Safety Defect and Noncompliance Report Guide for Vehicles
PART 573 Defect and Noncompliance Report¹

SERVICE ADVISORY # 05-053

Cambridge Dimmer Switch Wiring

Models Included: 2006 Cambridge 361 RLS & 358 RLS

Figure 1

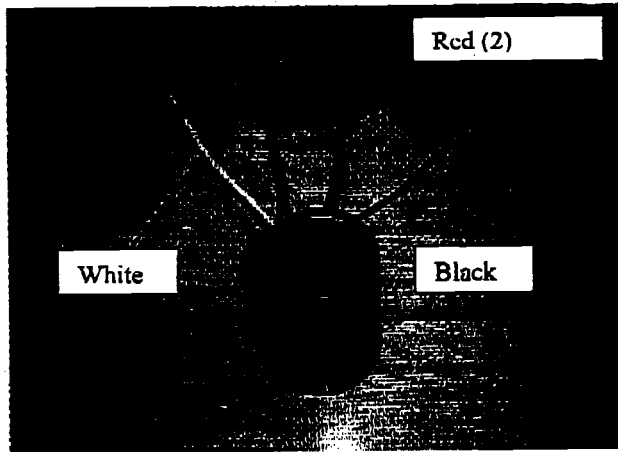
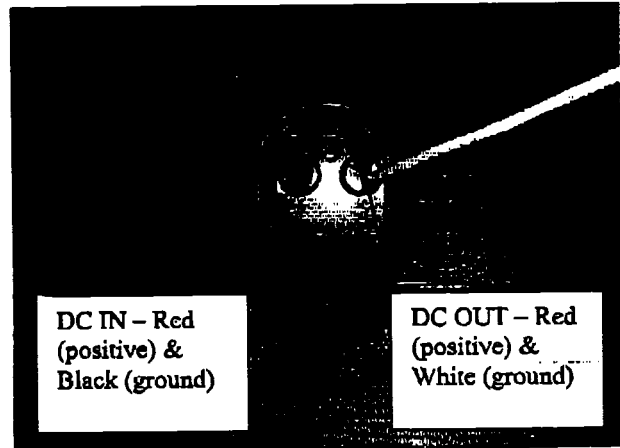
It has been determined that the wiring for the dimmer switches may be incorrect on the models listed above. The following repair procedure describes how to check for correct function of the dimmer switches and take corrective action if necessary.

7. Using a new switch, connect the wire pair with 12-volts present to the side of the switch marked "DC IN". The red wire on the switch goes to the colored positive 12-volt wire and the black wire on the switch goes to the white ground wire from the unit. See Figure 1 and 2.

8. Connect the other pair of wires to the "DC OUT" side of the switch. The colored wire from the unit goes to the red wire on the switch and the white wire from the unit goes to the white wire on the switch. See Figure 1 and 2.
